INDEX

"FIXES ARE GREAT IN '98"

INTRODUCTION

Figure 6

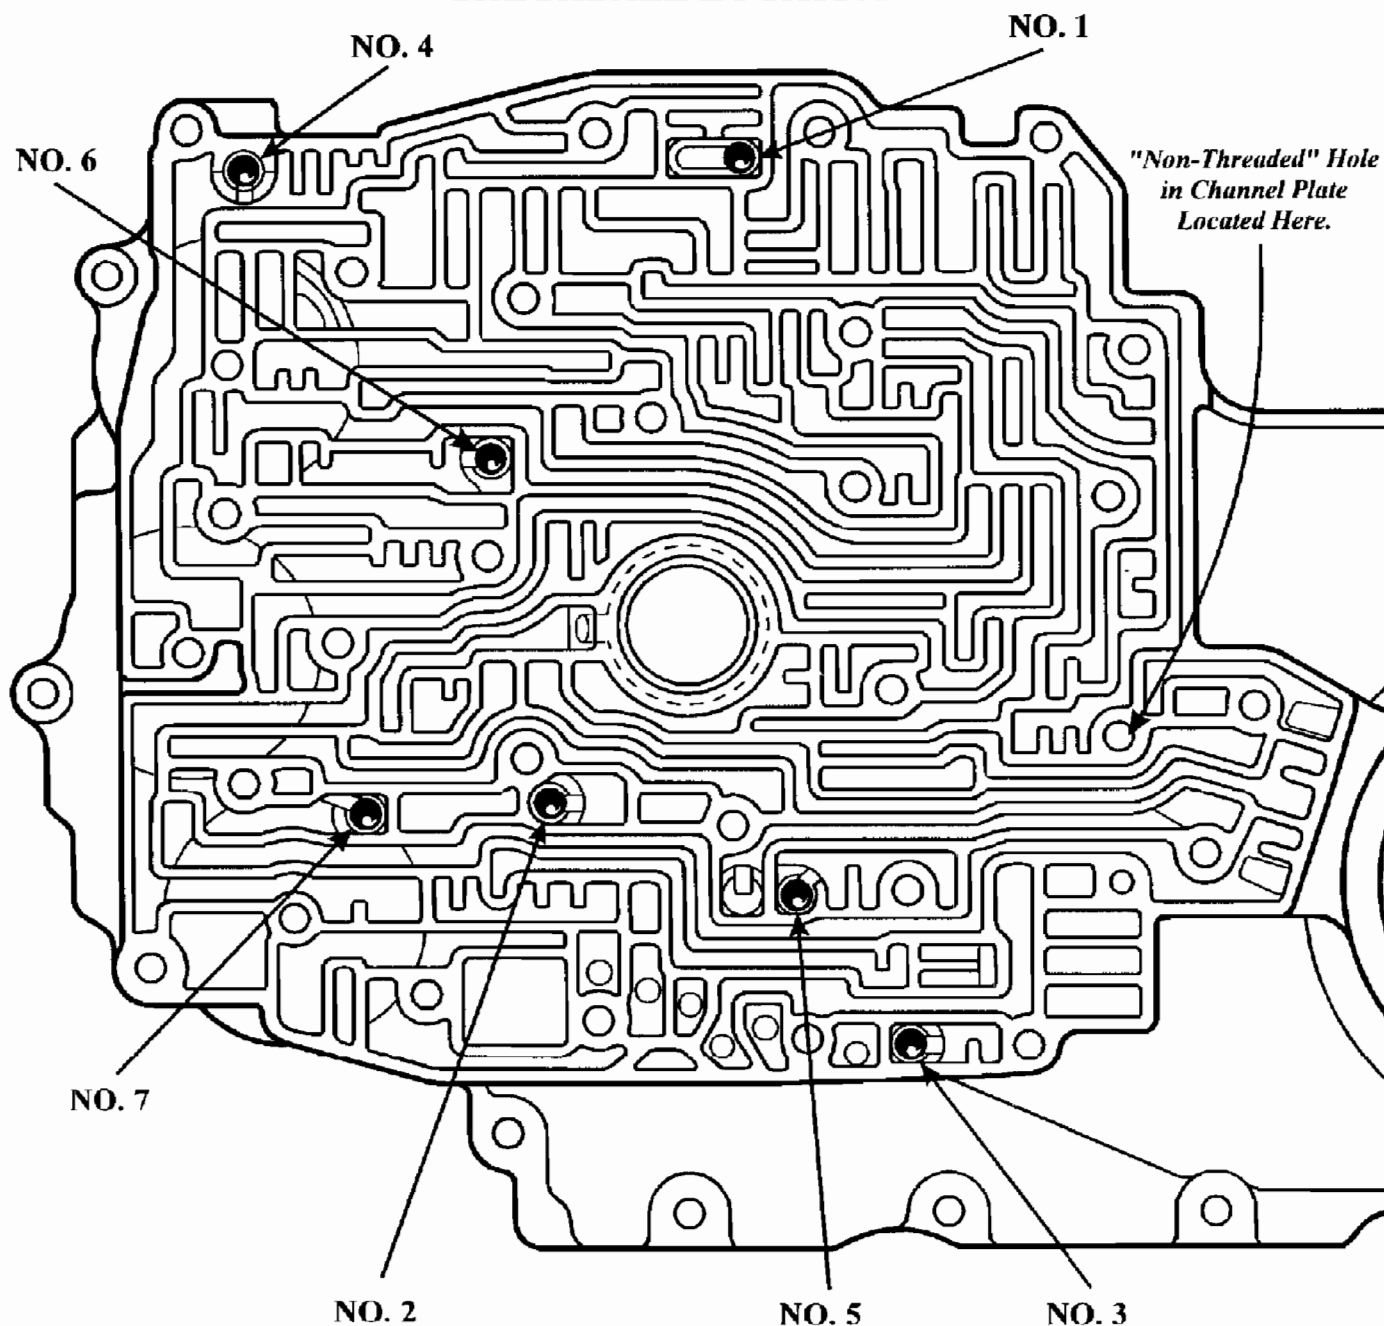
- (3) **CHECKBALL LOCATIONS** - The number 6 checkball moves from the direct clutch apply circuit, and into the 2-3 accumulator circuit. There were no changes in worm track configuration, however we also show the "Threaded" hole that changed to a "Non-Threaded" hole in the channel plate. Refer to Figure 5 for 1995-1996 checkball locations, and Figure 6 for the 1997-Up checkball locations.

Figure 7

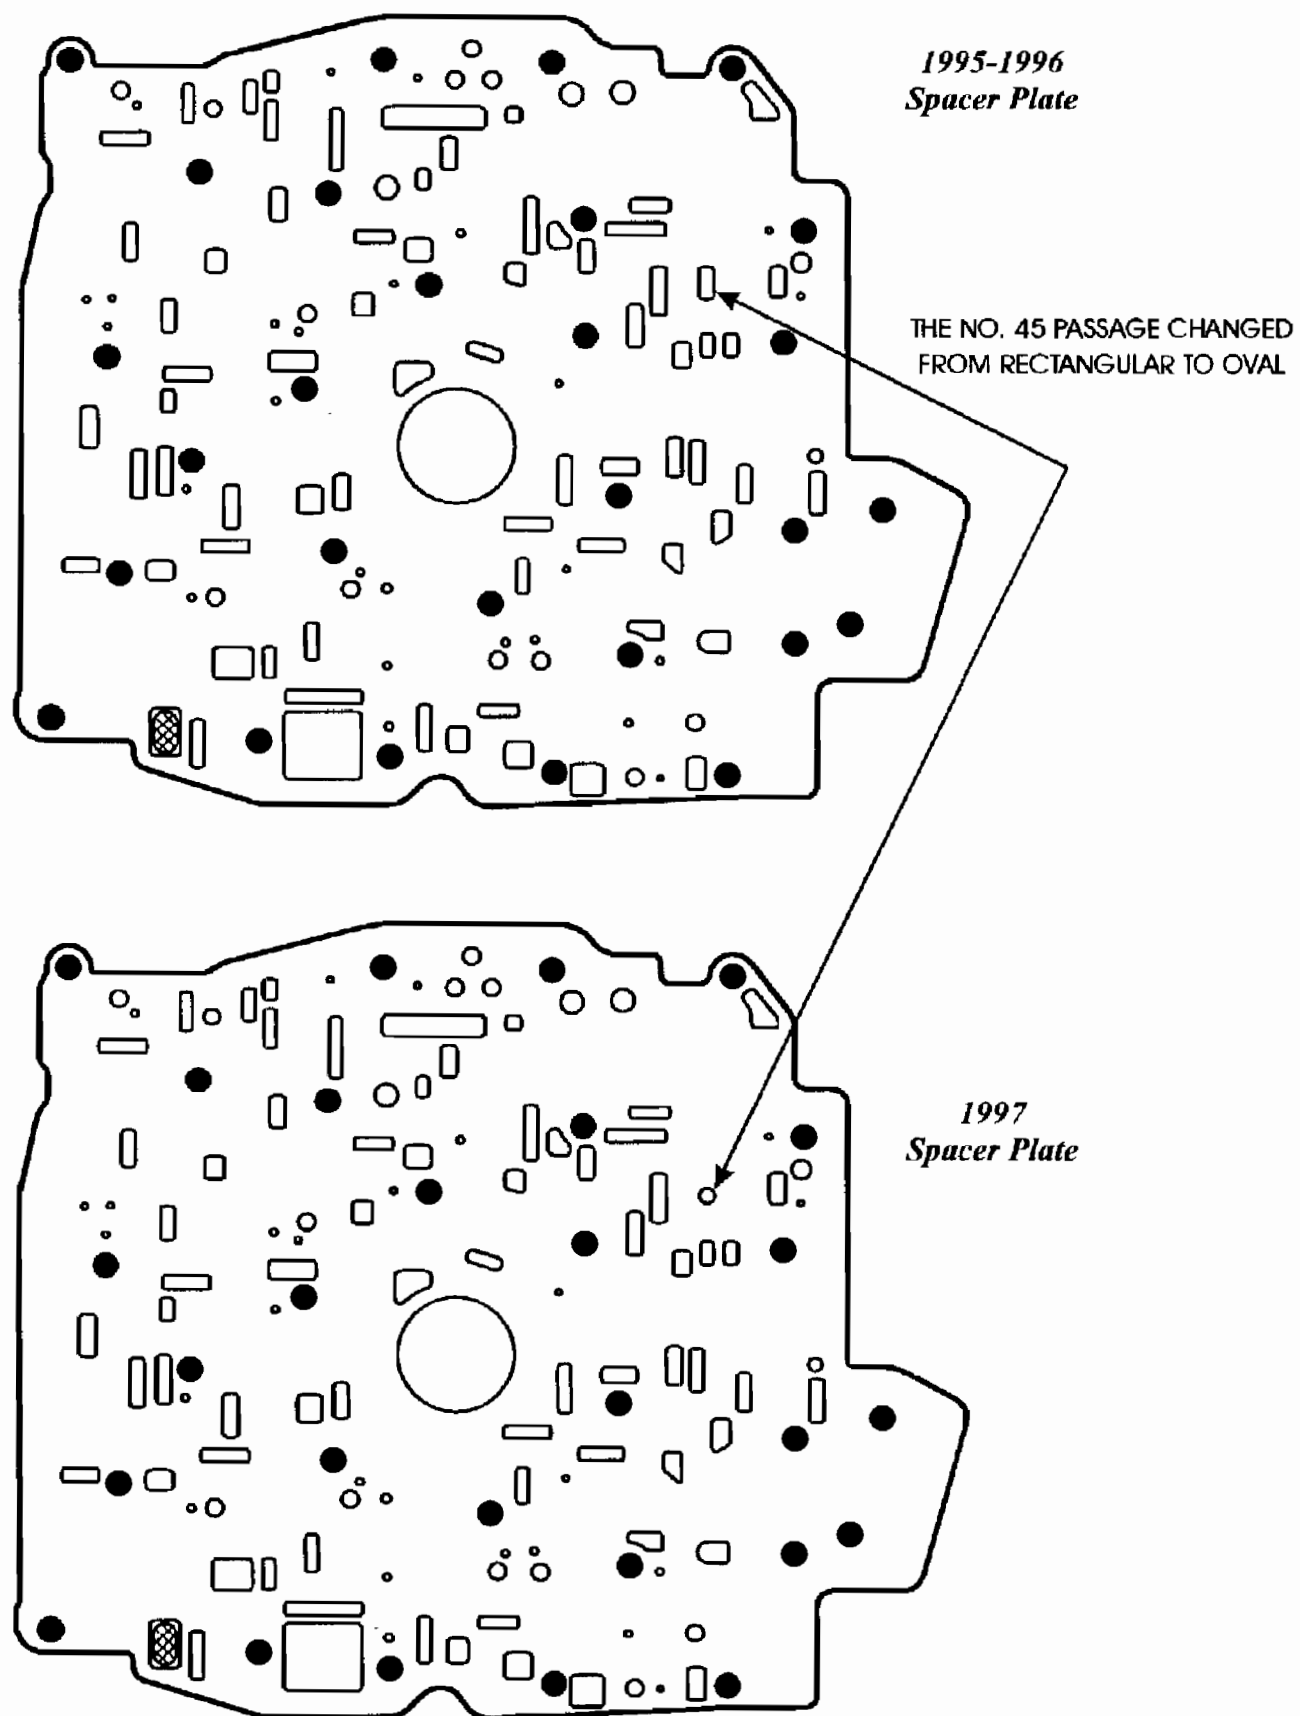
- (4) **SPACER PLATE** - The number 45 exhaust passage in the spacer plate has changed from a rectangular hole to a small oval hole, as shown in Figure 7.

Figure 8

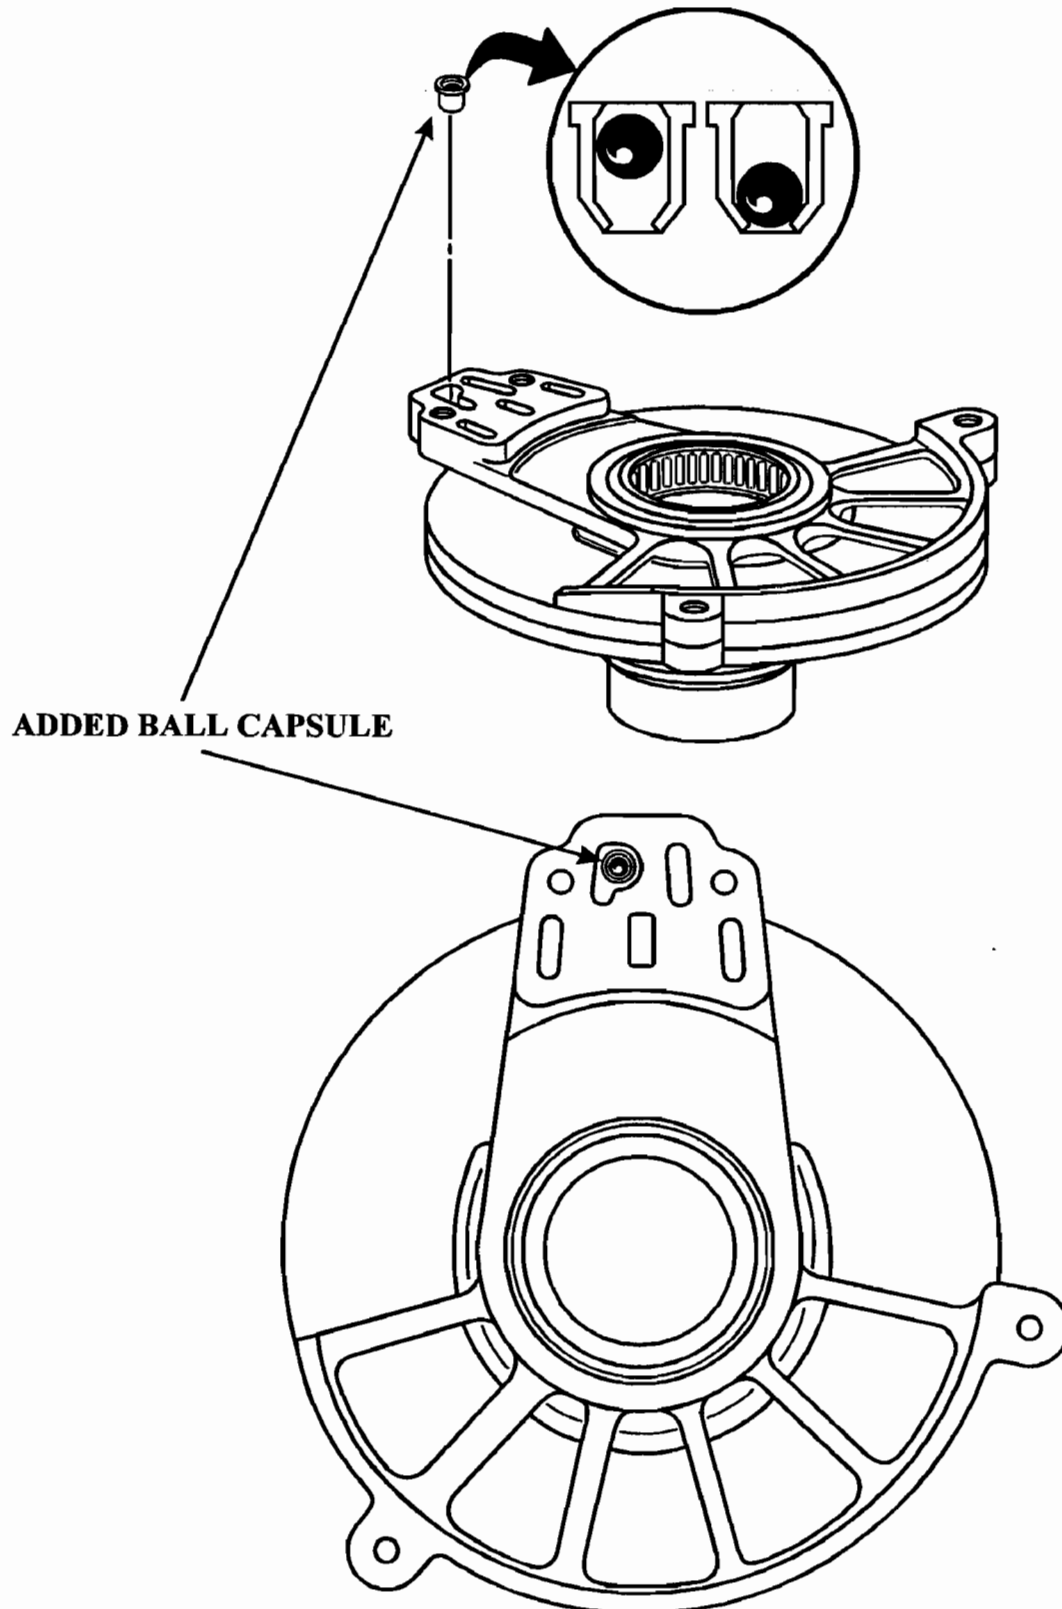
- (5) **DRIVEN SPROCKET SUPPORT** - Ball capsule added in the direct clutch circuit to act as an air bleed to improve direct clutch apply, as shown in Figure 8.

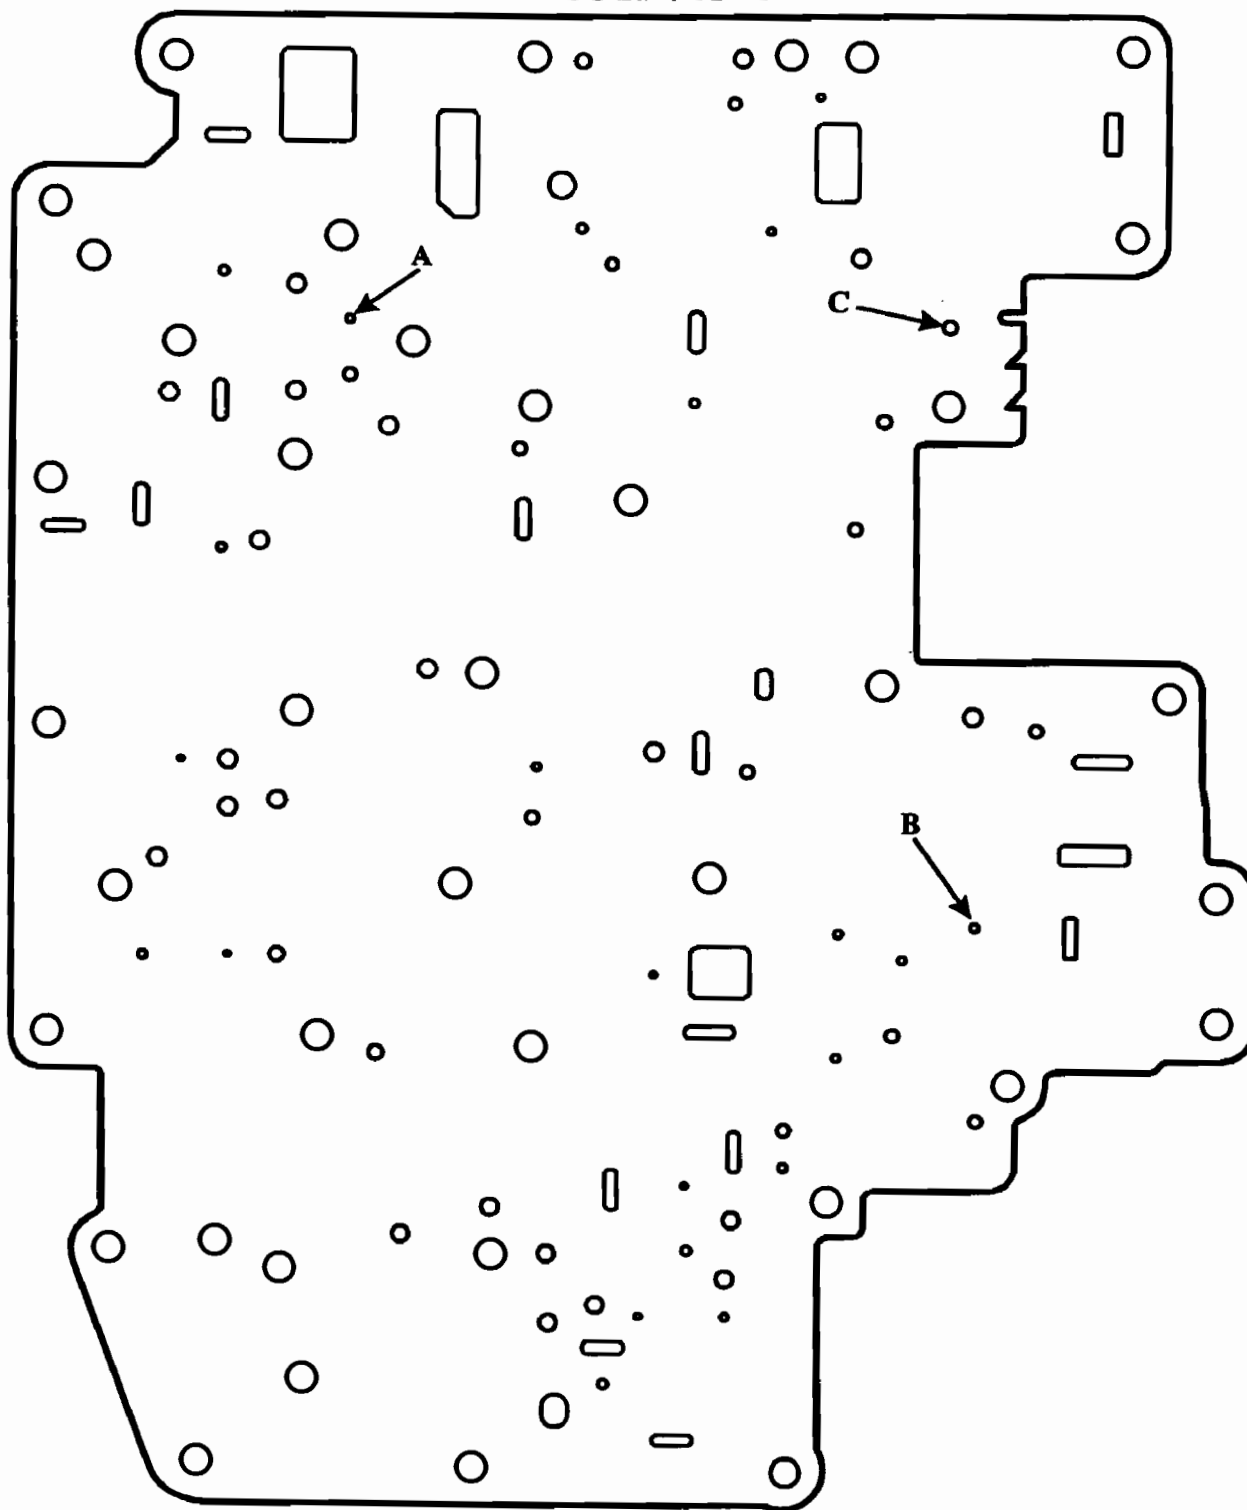
COMPLAINT: Before and/or after rebuild, the vehicle exhibits a converter clutch shudder condition, even with the proper Mercon® transmission fluid installed.

CAUSE: The cause may be, not enough oil to the converter clutch apply circuit.

CORRECTION: Drill the hole marked "A" in Figure 1 out to .062", which increases the volume of oil to the bypass clutch control valve apply circuit.

Drill the hole marked "B" in Figure 1 out to .062", which increases oil volume to the MCC/PWM solenoid. This increased oil to the valve's apply circuit ("A" orifice).

Restrict the hole marked "C" in Figure 1, to approximately .030" using a cotter key, which ensures that apply oil can overcome this balance circuit.

NEW DESIGN LEVEL TRANSMISSION CASE

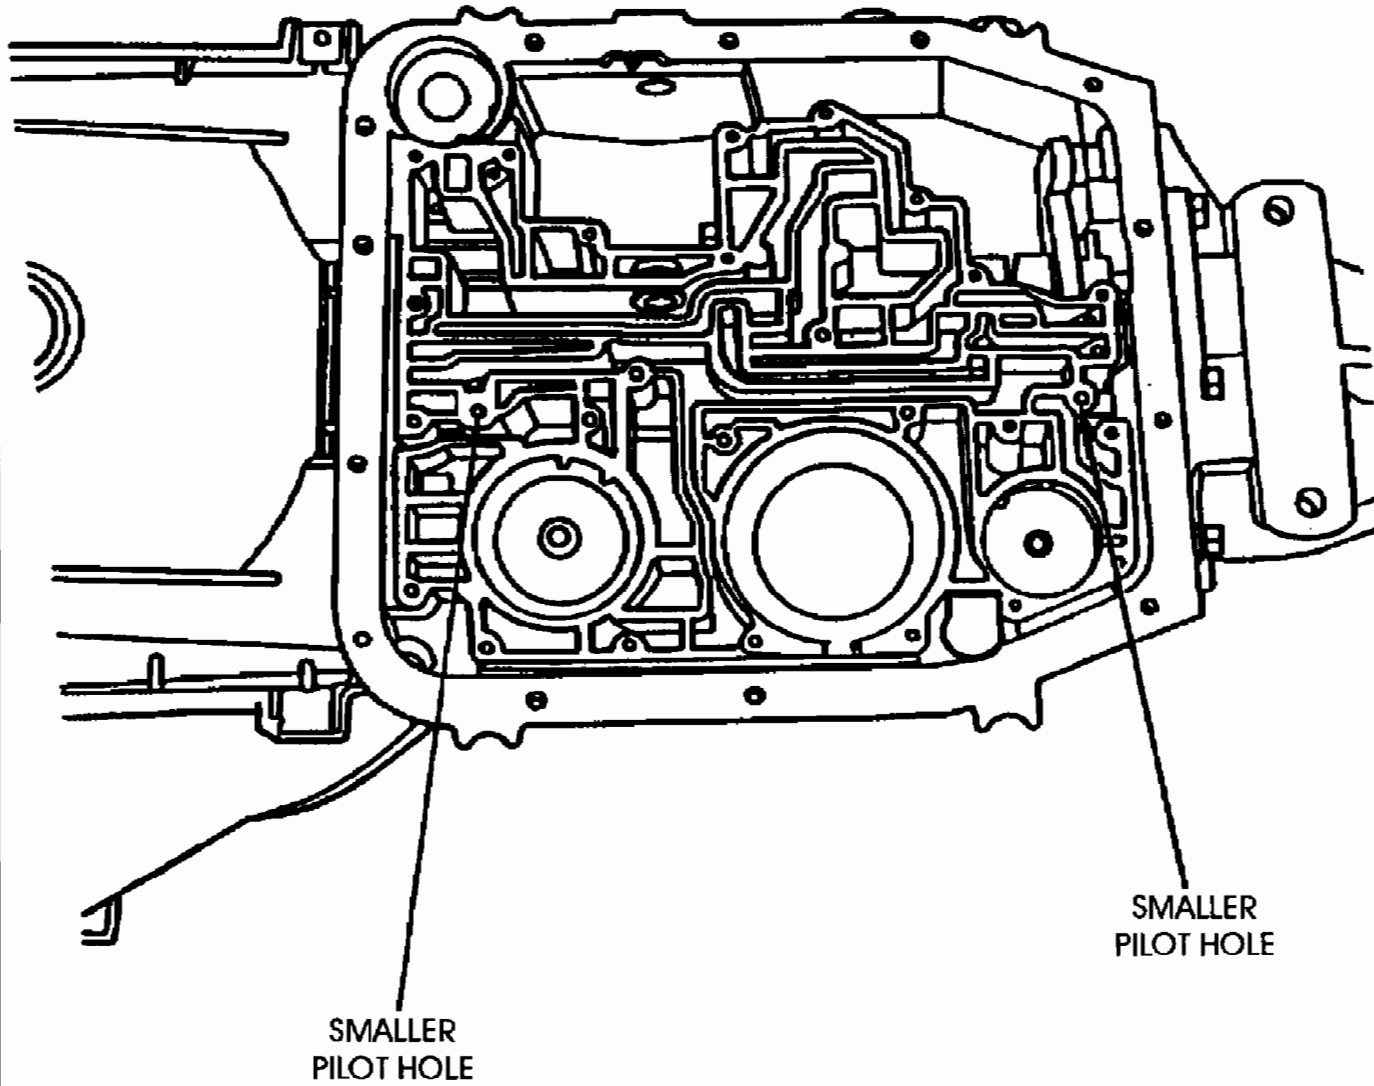
A new transmission case and valve body have been released for service for all 1992-1995 vehicles equipped with the AODE/4R70W transmission. The new transmission case pilot holes, used to align the valve body, have been reduced to accommodate the smaller pilots used on the new service valve body bolts. Refer to Figure 1.

Figure 1

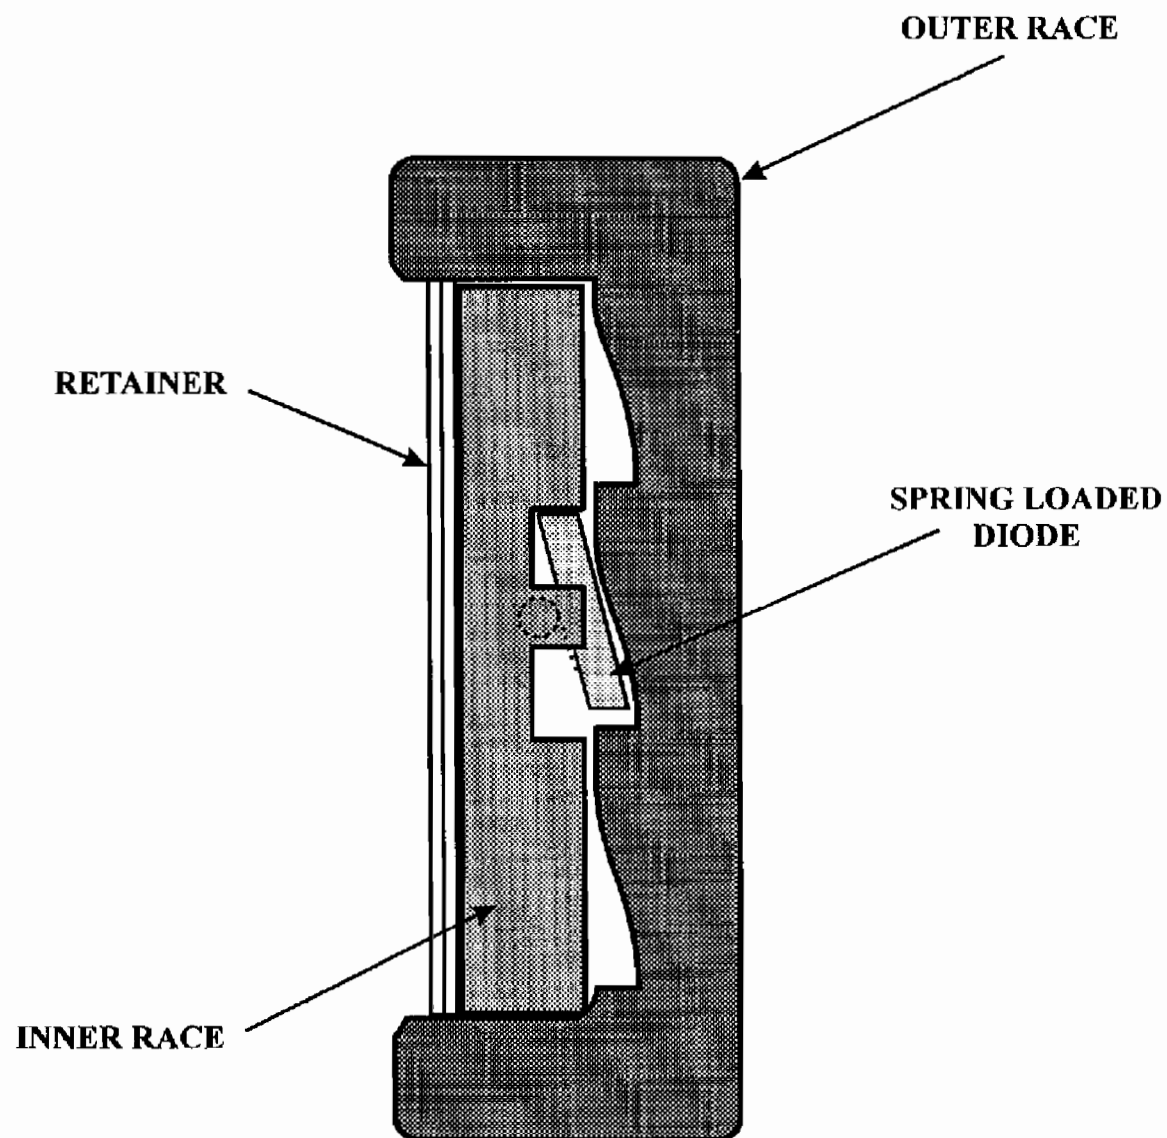
This new design can be manufactured in any configuration of outer race, inner race and retainer to hold the parts together, but all will have several spring loaded "Diodes" inside to do the holding and freewheeling. Refer to Figure 1 for a basic cross section of how a mechanical diode sprag assembly works.

- (1) **MECHANICAL DIODE SPRAG ASSEMBLY** - Totally new design to replace the previous design intermediate roller clutch in AODE and 4R70W transmissions (See Figures 1 and 2).
- (2) **REVERSE INPUT HOUSING** - New design housing with "Splines" in place of the previous inner race, to accommodate the new design mechanical diode sprag assembly. Refer to Figures 1 and 2.
- (3) **RETAINING RING** - No dimensional changes on the snap ring, you still use the original snap ring. When installed, the mechanical diode assembly may move back and forth approximately .010" and this is normal (See Figure 2).
